# Access Compliance Report

## Public Rights-of-Way

### (Curb Ramps)

Intersection ID: 2874	Main Street: HORNBEAM_CT	Cross Street: LADY_BANK_DR	Location: NE
ADA ID: 78F81CC67E9B	Ramp Type: Perp	Initial Pass/Fail: Fail	Overall Compliance: No
Severity Score: 46.25			
Codes/Mitigation Info/Possible Solution		Field Measurements/Component Compliance

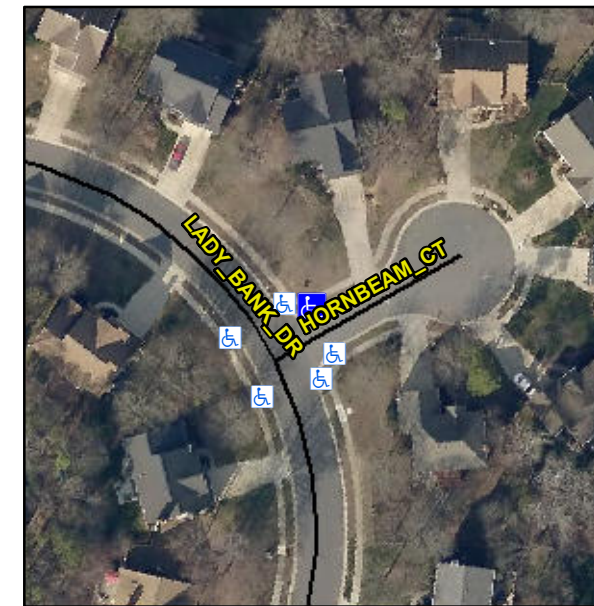
**R304.5.1, R304.2.2, R304.5.3**

Compliance	Description	Data	Compliance	Description	Data
N/A	Ramp Length (in)	50.0	No	Ramp Slope (%)	15.4
No	Ramp Width (in)	37.0	No	Ramp XSlope (%)	5.5
N/A	Flare Type LT	N/A	N/A	Flare Type RT	N/A
N/A	Flare Slope LT (%)	N/A	N/A	Flare Slope RT (%)	N/A
N/A	Flare Traversable LT?	N/A	N/A	Flare Traversable RT?	N/A
N/A	Landing Length (in)	N/A	N/A	DWS Provided?	N/A
N/A	Landing Width (in)	N/A	N/A	DWS Contrast?	N/A
N/A	Landing Slope (%)	N/A	N/A	DWS Length (in)	N/A
N/A	Landing X Slope (%)	N/A	N/A	DWS Full Width?	N/A
N/A	Landing Curb? (Y/N)	N/A	N/A	DWS Offset (in)	N/A
N/A	Shared Landing?	N/A			
N/A	Gutter Ponding?	N/A	N/A	Gutter Slope (%)	N/A
N/A	Gutter Lip Ht (in)	N/A	N/A	Gutter X Slope (%)	N/A
N/A	Painted X Walk1?	No	N/A	Painted X Walk2?	N/A
	X Walk 1 Direction	To S		X Walk 2 Direction	N/A
N/A	X Walk 1 Width (in)	N/A	N/A	X Walk 2 Width (in)	N/A
	X Walk 1 Slope (%)	1.8		X Walk 2 Slope (%)	N/A
	X Walk 1 X Slope (%)	5.3		X Walk 2 X Slope (%)	N/A

**Remove & Replace Entire Ramp.**
